ITEM: 6.4	COMMITTEE OF ADJUSTMENT REPORT SUMMARY MINOR VARIANCE APPLICATION FILE NUMBER A032/23 258 FARRELL ROAD, MAPLE
------------------	--

**COMMITTEE OF ADJUSTMENT REPORT
MINOR VARIANCE APPLICATION
A032/23
258 FARRELL ROAD, MAPLE**

ITEM NUMBER: 6.4	CITY WARD #: 4
APPLICANT:	Marina Rigenco and Oleg Rijenko
AGENT:	None
PROPERTY:	258 Farrell Road, Maple
ZONING DESIGNATION:	See Below
VAUGHAN OFFICIAL PLAN (2010) DESIGNATION:	Vaughan Official Plan 2010 ('VOP 2010'): "Low-Rise Residential"
RELATED DEVELOPMENT APPLICATIONS:	None
PURPOSE OF APPLICATION:	Relief from the Zoning By-law is being requested to permit the construction of a proposed deck (including stairs) and retaining wall.

TITLE:
SITE PLAN & PROPOSED DECK

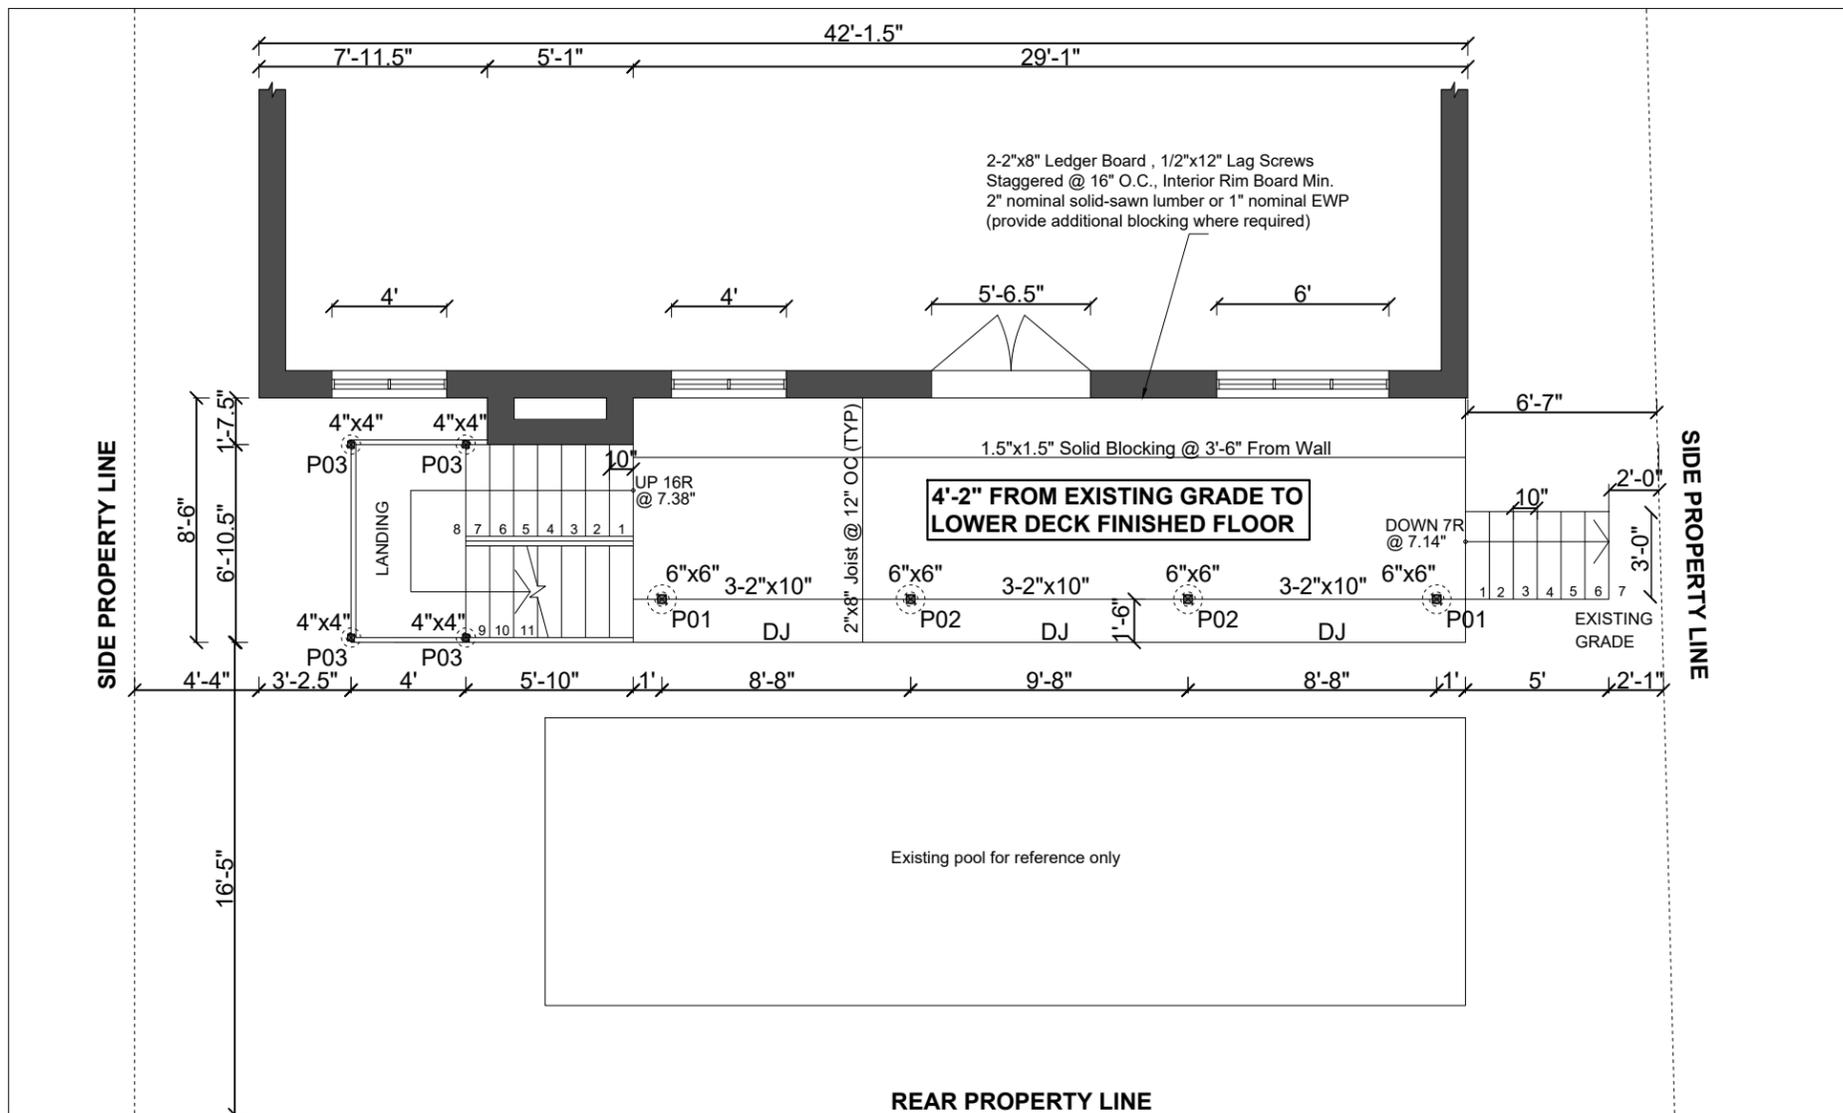
Development Planning staff have no objections to Variances 1, 3, and 4, as a maximum encroachment increase ranging from 0.1 m to 0.7 m is minimal and is not anticipated to be perceived by the adjoining neighbours. With respect to Variance 3, Development Planning and Development Engineering have no concerns with the location of the retaining wall, as it provides for a level rear yard, which increases its functionality. It should also be noted that a 0.0 m rear yard setback in this circumstance is acceptable given this lot abuts open space and the height of the retaining wall is less than the established fence line. No massing impacts are anticipated.

Development Planning staff is of the opinion Variances 2 and 5, a maximum encroachment of 0.59 m into the minimum required interior side yard (1.2 m), does not uphold the general intent and purpose of By-law 001-2021. A 0.61 m setback between the stair edge and southeastern lot line would remain. The primary access between the front and rear yards without passing through the dwelling is located in the southeastern interior side yard, which has concrete steps to navigate the grade change between the

The Development Planning Department recommends **approval** of Variances 1, 3 and 4, and **refusal** of Variances 2 and 5, as noted above.
